INITIAL FIRE SAFETY INSPECTION REPORT

Sadma Fashion Wear Ltd. (Extension 2)

RSC ID: 24729

Date: 01-Oct-2024

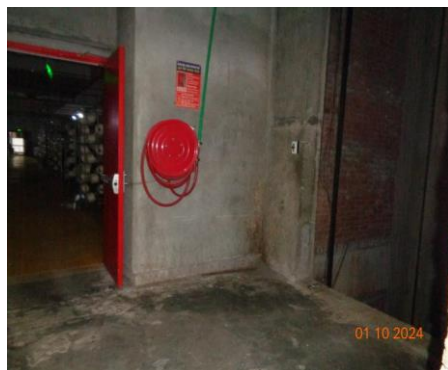
F-2	Means of Egress	The exterior exit ramps are not separated from the building exterior openings which are located within 10 ft . Location: Building-1	The unprotected opening for any side of the exterior walls shall be sealed or protected by minimum 1 hr. fire rated materials so that the protected diagonal distance not being less than 10ft from exterior exit ramp beyond the ends of the ramp.	Within 3 months
-----	-----------------	--	--	-----------------

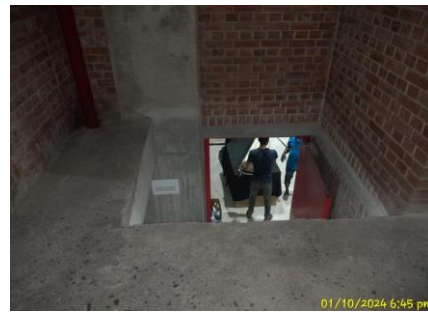
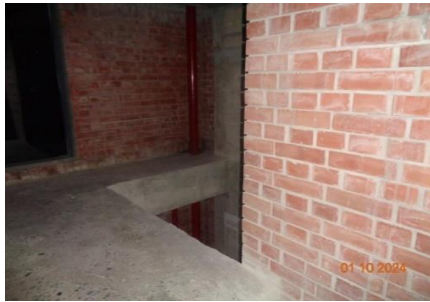
F-17	Means of Egress	Stair width was found less than 1.5m (60 inches) (Stair-01). Location: Building-1.	Stairs shall have a minimum clear width of 1.5 m (60 in.) for all industrial occupancies	Within 3 months
F-18	Inspection, Testing & Maintenance (Fire)	Hot work (welding, cutting, Grinding) has been observed on 3rd floor, hot work policy was not being maintained properly. No adequate safety precautions has been taken where heavy fire load (Fabric warehouse) is located just adjacent to hot work. Location: Building-1.	A hot-work permit system in accordance with NFPA 51B shall be provided for any construction in an occupied facility & shall maintain properly. A fire watch personnel shall be assigned during hot work.	Within 1 month

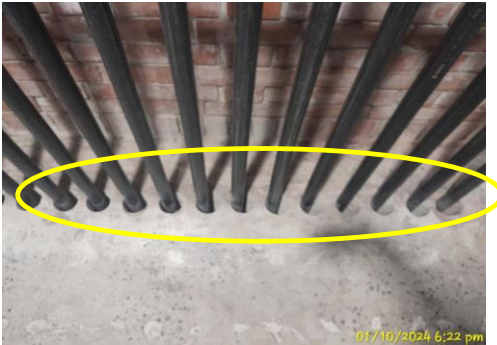
F-23	Means of Egress	Falling hazard has been identified on the 3rd floor, stair-1. Location: Building-2, Stair-1	Stairways serving as means of escape or use for operational purpose or open shaft shall have continuous guards and handrails on all sides. Guards shall have a minimum height of 1067 mm (42 in.). Open guards shall have intermediate rails or patterns such that a sphere 200 mm (8 in.) in diameter cannot pass through any opening up to a height of 865 mm (34 in.).	Immediate

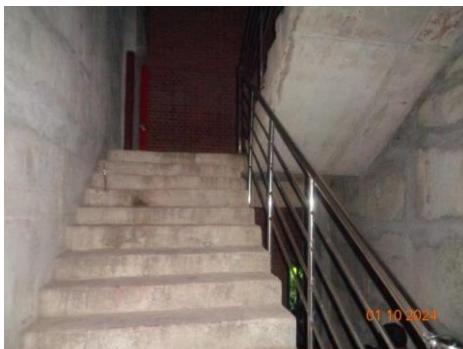
F-31	Fire Rated Construction	Elevator are under installation and elevator shafts are directly open into exit stair enclosures which is a violation of RSC Technical Guidelines (Standard)-6.14.3. Location: Building-3 (South Stair)	Ensure minimum 1.5-hr fire rating for the doors of elevator shafts otherwise close the shafts area with 2-hr fire rated construction barrier and 1.5-hr fire rated opening protective as per RSC Building Standard 6.14.3. Factory is recommended to follow RSC published "SUPPLEMENTARY PAPER ON REMEDIATION GUIDANCE ELEVATOR OR LIFT SHAFT OPENING IN EXIT ENCLOSURES" for different solutions.	Within 3 months
